SERVICE BULLETIN

PRO SERIES 12,000 LB. STATIC CAPACITY JACK WASHER INSERT INSTRUCTIONS

12 K Cequent Jack

Date Stamp Location

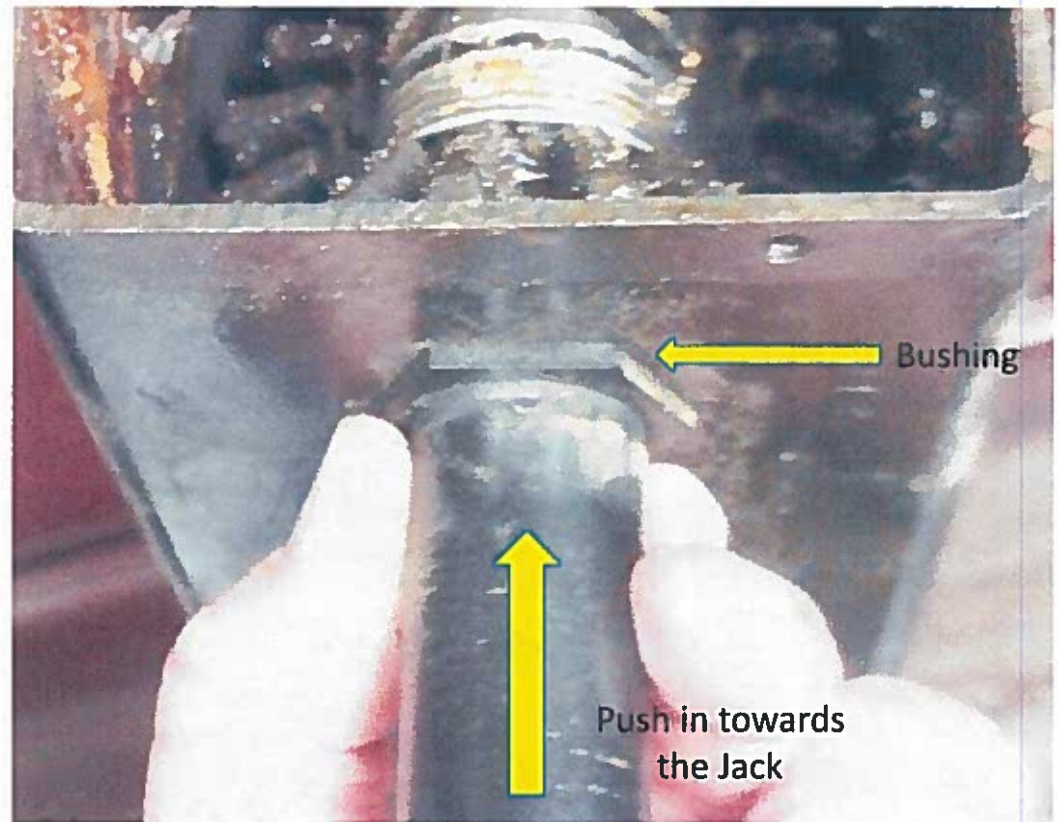
- Locate the manufacturing date code: it will be located in this upper right side of the jack adjacent to the handle, with the jack still orientated in the same direction as the picture on slide #1.
- Look for "F14" or "M14" – if you find any "F14" do not use this unless absolutely necessary; if you find "M14" follow the inspection and verification testing called out on slide #3.
